# **CREEKWALK NORTH**

**Appeal of Development Plan and Plat  
File Numbers: AR DP 21-00551 and AR FP 21-00552**

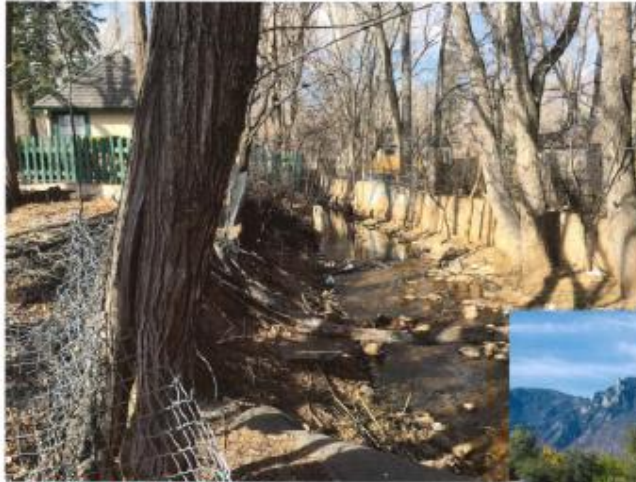
The Plan does not adequately address Steps 3 of the Four Step Process, which requires the stabilization of stream channels.

Even though the Phase 1 Underground BMP outflows directly to Cheyenne Creek, the Plan pushes all Creek improvement and stabilization to Phase 2, with no promise that the next phase will even occur.
